PAC BULLETIN

WARRANTY CAMPAIGN

Can-Am® On-Road Ryker™

Subject: **219400843 - Foldable Passenger Backrest -
Pivot Attachment Missing Bolts**

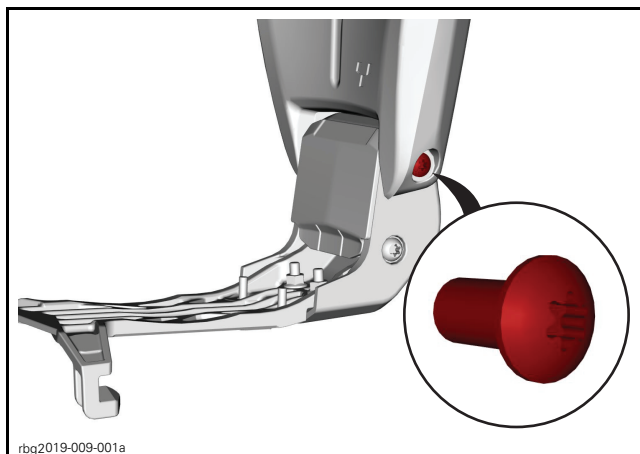
Due to inappropriate assembly, the passenger backrest may be missing pivot retaining screws.

Ensure the that the pivot retaining screws are present.

If the inspection reveals that the screws are present:

If the inspection reveals that some screws are missing:

- Install the screws, refer to instruction sheet (P/N 487802566) available on the *KNOWLEDGE CENTER* for part number and torque specification.
- Claim the inspection according to the *WARRANTY* section.
- Submit a separate *REPLACEMENT PARTS/ACCESSORY* claim to cover for the screw installation. 0.2 hours are allowed to perform this operation.
